MODBAR TECHNICAL BULLETIN #26 Wand spacer on new steam Tap

We would like to inform you about a recent modification in the wand assembly of the new steam tap.

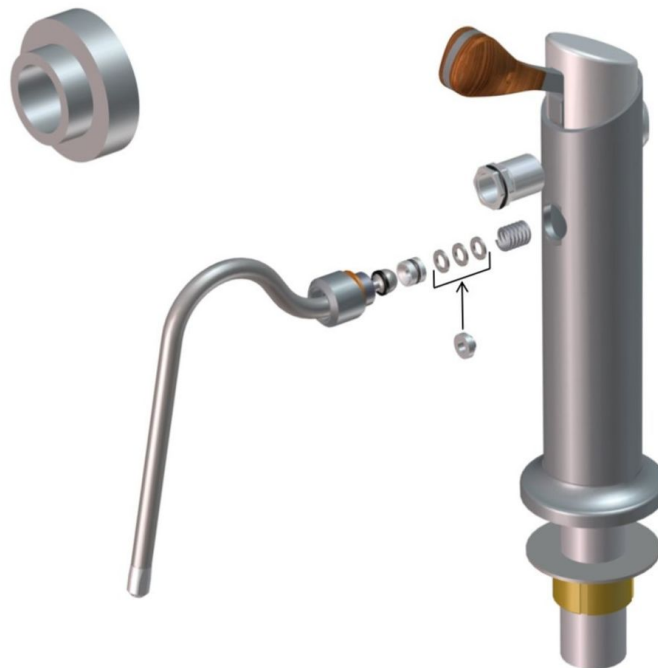
To ensure a more precise pre-load of the spring, the 3 washers L1003 have been substituted with a new part, which is machined with very reduced tolerances.

Since the washers were not enough precise for this application, they could make the joint be more or less tight, depending on their thickness. That can make the wand be loose or damage the teflon seal, which can, in some cases, occlude the steam pathway and reduce the steam pressure when the steam wand is fully upright.

This modification takes effect from serial number S00023068 and ST00033025 (extra tap) and it's easily retrofittable on previous taps.

The new part is available with code F.3.113.
